# Access Compliance Report

## Public Rights-of-Way

Intersection ID: 4139	Main Street: FOGGY_BANK_LN	Cross Street: PITAL_CT	Location: W
ADA ID: 38DA620F8BF2	Ramp Type: BlendTrans1	Initial Pass/Fail: Fail	Overall Compliance: No
Severity Score: 33.75			
Codes/Mitigation Info/Possible Solution		Field Measurements/Component Compliance

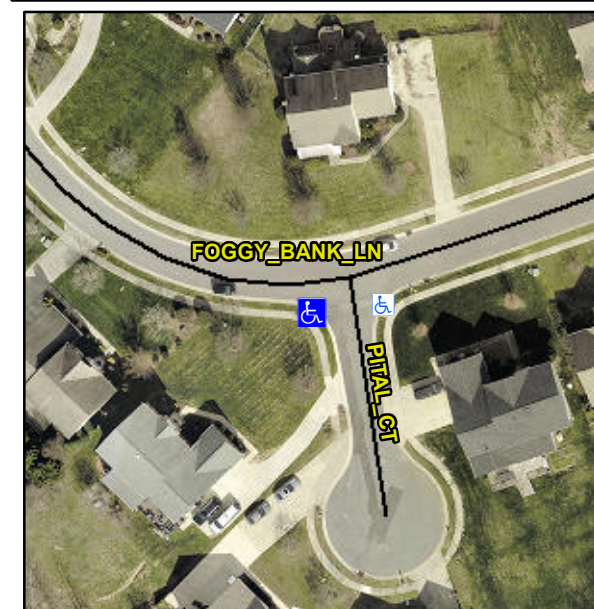
**R304.5.1, R304.5.3**

Compliance	Description	Data	Compliance	Description	Data
N/A	Ramp Length (in)	45.0	Yes	BlendTrans Slope (%)	3.1
No	Ramp Width (in)	40.5	No	BlendTrans XSlope (%)	7.2
N/A	Flare Type LT	N/A	N/A	Flare Type RT	N/A
N/A	Flare Slope LT (%)	N/A	N/A	Flare Slope RT (%)	N/A
N/A	Flare Traversable LT?	N/A	N/A	Flare Traversable RT?	N/A
N/A	Landing Length (in)	N/A	N/A	DWS Provided?	N/A
N/A	Landing Width (in)	N/A	N/A	DWS Contrast?	N/A
N/A	Landing Slope (%)	N/A	N/A	DWS Length (in)	N/A
N/A	Landing X Slope (%)	N/A	N/A	DWS Full Width?	N/A
N/A	Landing Curb? (Y/N)	N/A	N/A	DWS Offset (in)	N/A
N/A	Shared Landing?	N/A			
N/A	Gutter Ponding?	N/A	N/A	Gutter Slope (%)	N/A
N/A	Gutter Lip Ht (in)	N/A	N/A	Gutter X Slope (%)	N/A
N/A	Painted X Walk1?	No	N/A	Painted X Walk2?	N/A
	X Walk 1 Direction	To E		X Walk 2 Direction	N/A
	X Walk 1 Width (in)	N/A		X Walk 2 Width (in)	N/A
	X Walk 1 Slope (%)	7.1		X Walk 2 Slope (%)	N/A
	X Walk 1 X Slope (%)	0.7		X Walk 2 X Slope (%)	N/A

**Remove & Replace Curb Ramp With Two New Directional Ramps or Equivalent.**
